Country Club Hills, Preliminary Plan, 120140110

Staff Report Date: 12/18/15

Description

- Request: Combine Parts of Lots 8 and 9 into one lot
- Address: 5712 River Road
- Size: 0.19 acre
- Zone: R-60
- Master Plan: Bethesda-Chevy Chase (1990)
- Applicant: Nick Bauman
- Submittal Date: June 24, 2014

Figure 3: Preliminary Plan of Subdivision
 (Proposed Lot 29 outlined in solid red line, access easement outlined in dashed red line.)

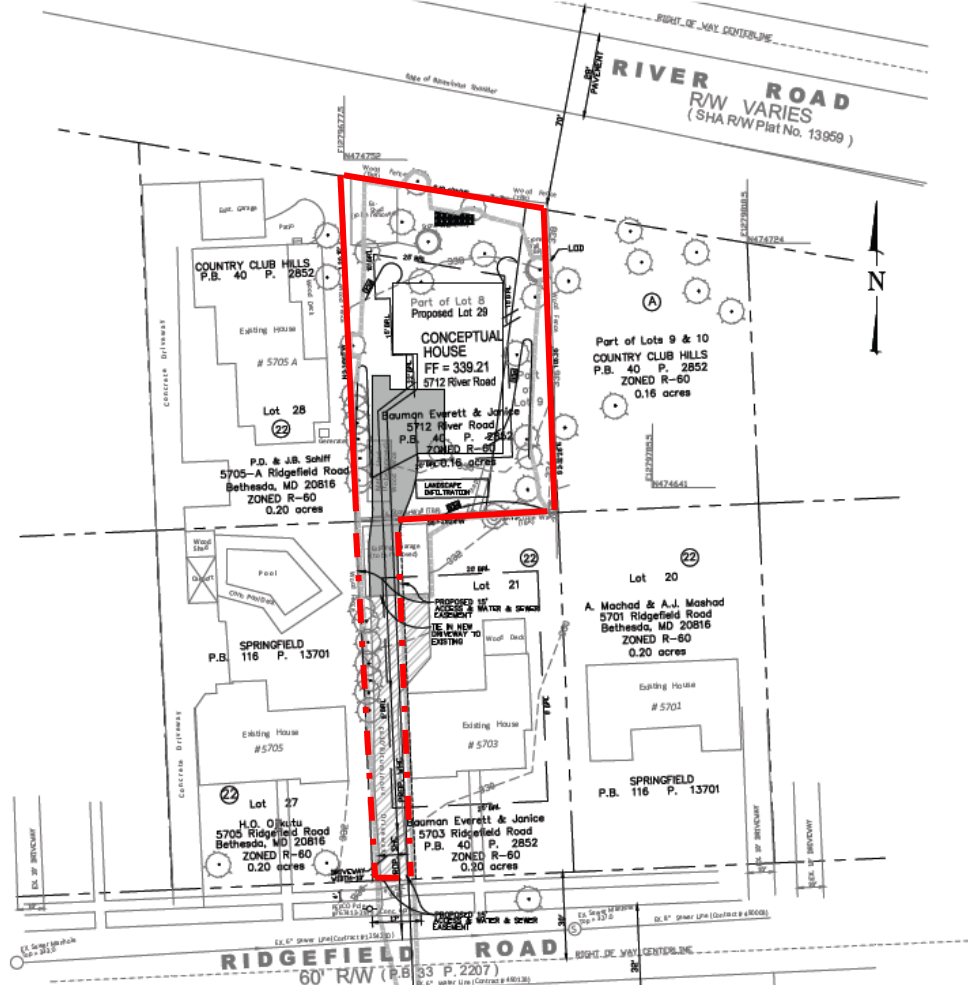
- 10) Prior to approval of the certified Preliminary Plan, the Applicant must undertake the following revisions to the submitted Preliminary Plan:
 - a. Correct Note #10 regarding Building Setbacks to show correction dimensions for Proposed Lot 29 as front yard: - 25 feet; and rear yard: - at 20 feet.

b. Correct Note #14 to read: "Access for the new lot will be off Ridgefield Road via a 10-foot access easement through Lot 21, Block 22."
